Service Campaign Bulletin

Campaign No. 2018040008, June 2018

SUBJECT: **Model A205, Model Year 2018**
Check Luggage Cover

Figure 1

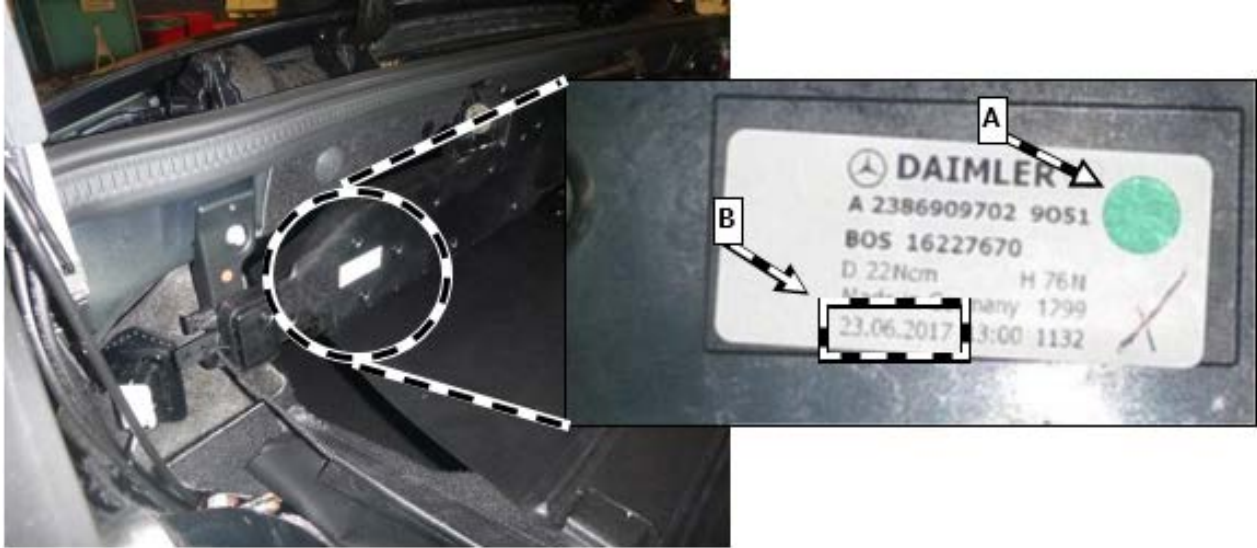
1. Move soft top to repair position R2.
☐ **i** For basic data, see AR77.30-P-1030LWR.
2. The marking (dot, (A)) and production date (B) must be checked (figure 1) on the object number adhesive label of the partially electric truck luggage cover.
☐ **i** The marking can be a green, blue or black dot (A).

- a. Marking (dot) present :End measure.
- b. Marking (dot) **not** present and production date **same as/later than** 24.06.2017 :End measure.
- c. Marking (dot) **not** present and production date **before** 24.06.2017 :Carry out **check/test procedure B**.

Figure 5

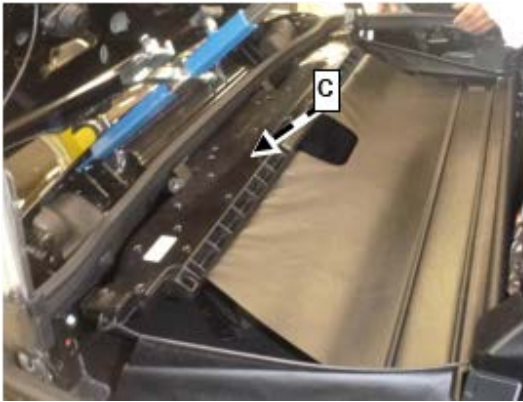
2. Remove cover **(C)** of partially electric trunk luggage cover **(figure 5)**.

Figure 6

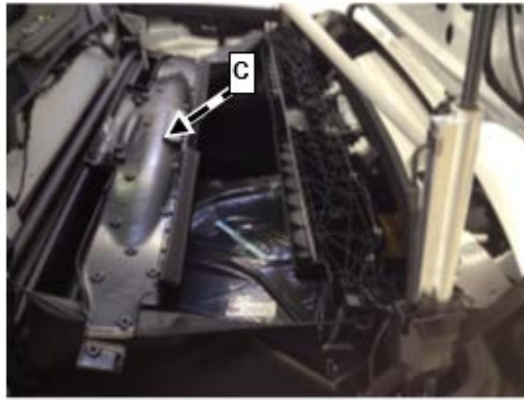
i For this purpose, remove all 23 screws and place cover **(C)** to side on net **(figure 6)**.

Figure 7 (NOT OK)

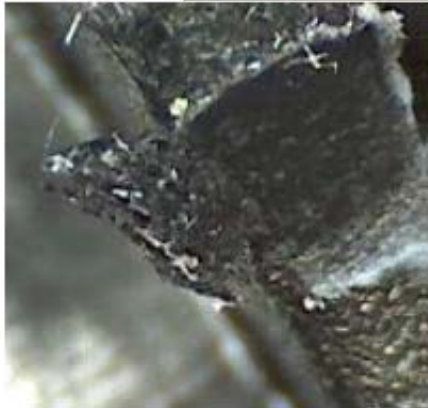
3. Check rib of housing below plunger.

i Rib of housing may not be damaged **(figure 7)**.

1. Replace partially electric trunk luggage cover.
 **AR68.50-P-3003LWR.**

Figure 8 (NOT OK)

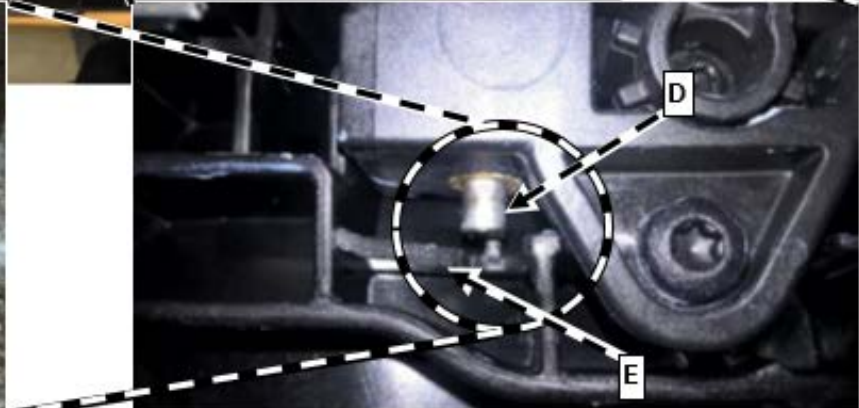
i The plunger **(D)** must be able to freely move through the rib **(E)** **(figure 8)**.

Figure 10 (NOT OK)

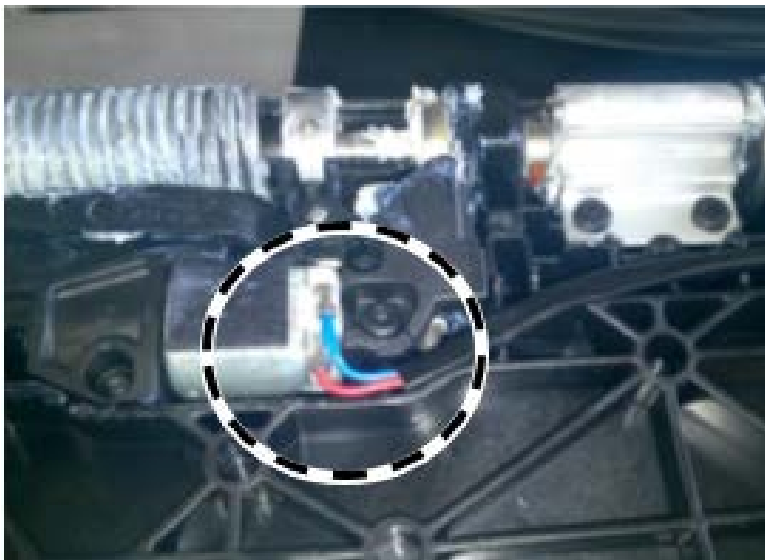
- i Check cable set of partially electric trunk luggage cover.
- 4. Check position of flat-wire connectors (**F**) of electrical cable set for drive (**figure 9**).
- i Flat-wire connectors may not lie one above the other (**figure 10 (not OK image)**).

1. Correctly position flat-wire connectors.
2. Route blue cable (**G**) along threaded connection opening (**figure 12**).
3. Route red cable (**H**) downwards (**figure 12**).

4. Attach fabric tape (**I**) over red flat-wire connectors (**figure 13**).

Work procedure A

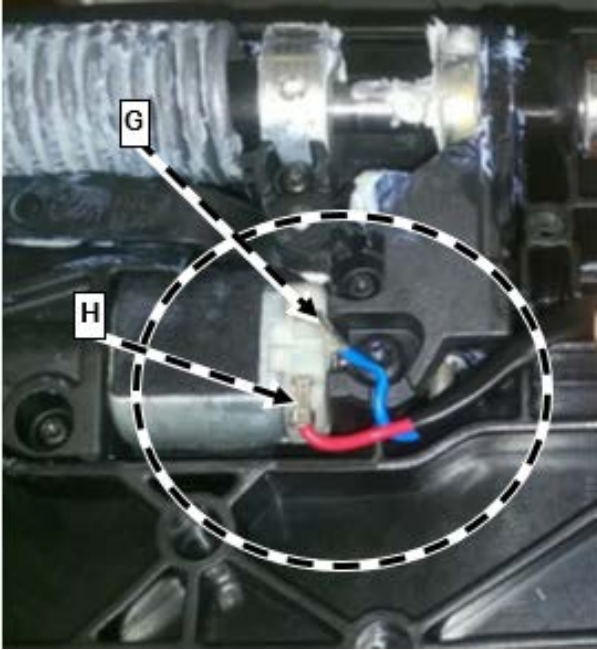
- a. All test conditions **OK**:
Assemble in reverse order and **end measure**.
- b. Heat-sealing of magnetic pocket **not OK**:
Carry out **work procedure A**.
- c. Rib of housing below plunger **not OK**:
Carry out **work procedure A**.
- d. Cable set **not OK**:
Perform **work procedures B and C**.
- e. Position of flat-wire connectors **not OK**:
Carry out work procedure C.

Work procedure B

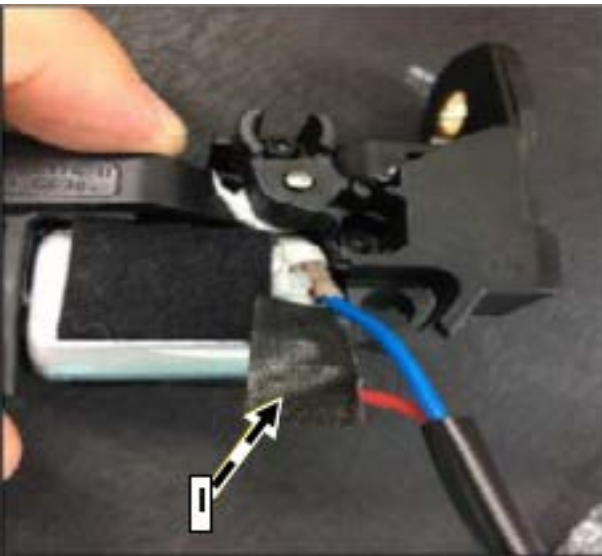
5. Check cable set for damage (**figure 11**).

1. Repair cable set at damaged location.
 **AR00.19-P-0100A.**
